# Work Order ID 67074

Item Name: 205 Skidtube bent detail

DRAWING NO. D2580	TITLE 205 SKIDTUBE ASSEMBLY	REV. D	<b>DART AEROSPACE LTD ENGINEERING ORDER</b>	D.E.O. NO. D2580-D-1	SHEET NO. SHEET 1 OF 1	SCALE NTS
DRAWN <i>UP</i>	CHECKED <i>L</i>	MFG. APPR. <i>E</i>	APPROVED <i>MP</i>	DE APPR. <i>H</i>		
DATE 10.09.22	DATE 10.11.04	DATE 10.11.04	DATE 10/11/04	DATE 10.11.04

CHANGE ALL WELDED CROSSBOLT SPACERS TO SWAGED SPACERS

SECTION D-D & SECTION H-H ARE AMENDED AS FOLLOWS:

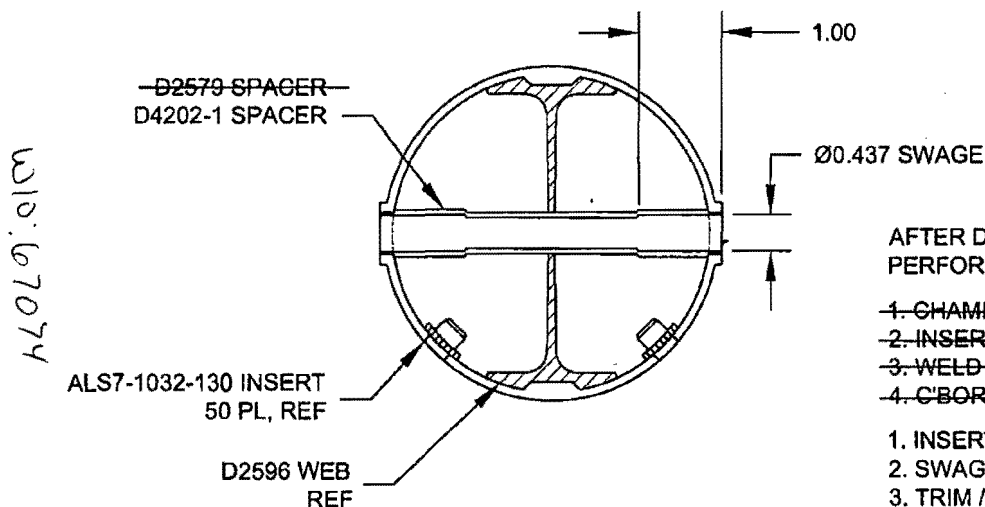
- ~~1. CHAMFER HOLE 0.050 X 45°~~
- ~~2. INSERT D2579 SPACER (20 PLACES)~~
- ~~3. WELD INTO PLACE AND GRIND FLUSH~~
- ~~4. C-BORE D2579 SPACER TO Ø0.437 X 1.00 DEEP~~

20	24	D4202-1	SPACER
----	----	---------	--------

1. INSERT D4202-1 SPACER, 20 PL (-041) OR 24 PL (-045)
2. SWAGE TO Ø0.437 X 1.00 DEEP PER QSI 002
3. TRIM / GRIND FLUSH PER QSI 002
